DART AEROSPACE LTD		Work Order: 99469
Description: Crosstube Assembly (205/212/412 High Fwd)		Part Number: D212-664-141
Inspection Dwg: D212-664-141 Rev: D		Page 1 of 2

DRAWING NO. D212-664-141	TITLE XTUBE ASSY (205/212/412 HI FWD)	REV. D	DART AEROSPACE LTD ENGINEERING ORDER		D.E.O. NO. D212-664-141-D-1	SHEET NO. SHEET 1 OF 2	SCALE NTS
DRAWN	CHECKED <i>OP</i>	MFG. APPR. <i>R</i>	APPROVED <i>NA</i>		DE APPR. <i>NA</i>		
DATE 11.04.07	DATE 11.04.11	DATE 11.04.12	DATE 11/04/12		DATE 11.04.12

DRAWING NO. D212-664-141	TITLE CROSSTUBE ASS'Y (205 HI FWD)	REV. D	DART AEROSPACE LTD ENGINEERING ORDER		D.E.O. NO. D212-664-141-D-2	SHEET NO. SHEET 1 OF 1	SCALE NTS
DRAWN <i>UP</i>	CHECKED <i>ASS</i>	MFG. APPR. <i>AS</i>	APPROVED <i>MD</i>		DE APPR. <i>TH</i>		
DATE 11.07.15	DATE 11.07.20	DATE 11.07.21	DATE 11/07/21		DATE 11.07.21

DRAWING NO. D212-664-141	TITLE XTUBE ASSY (205/212/412 HI FWD)	REV. D	DART AEROSPACE LTD ENGINEERING ORDER		D.E.O. NO. D212-664-141-D-3	SHEET NO. SHEET 1 OF 1	SCALE NTS
DRAWN AJS	CHECKED qp	MFG. APPR. 140	APPROVED 140	DE APPR. 140	DATE 12.06.28	DATE 12.07.05	DATE 12.07.05

**D212-664-141/-141B
ASSEMBLY DETAIL**

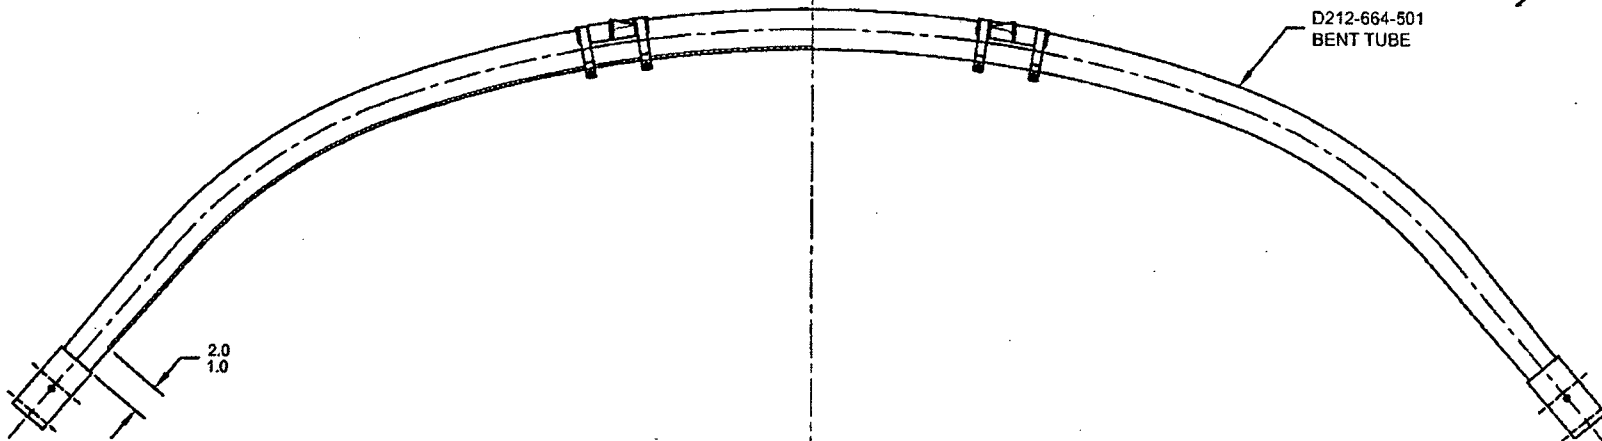
ADD AN INSPECTION WINDOW TO UNDERSIDE OF CROSSTUBE.

NOTES 2 OF SHEET 1 IS AMENDED AS FOLLOWS:

IS:

WAS:

- 2) FINISH: CHEMICAL CONVERSION COAT PER DART QSI 005 4.1
PRIME INSIDE AND OUTSIDE PER DART QSI 005 4.2
MASK UNDERSIDE OF CROSSTUBE AS SHOWN (HATCHED AREA) AND
PAINT OUTSIDE PER DART QSI 005 4.2
REMOVE MASKING AND APPLY CLEAR COAT

MASK AREA PRIOR TO PAINTING,
REMOVE MASKING AFTER PAINT
AND APPLY CLEAR COAT
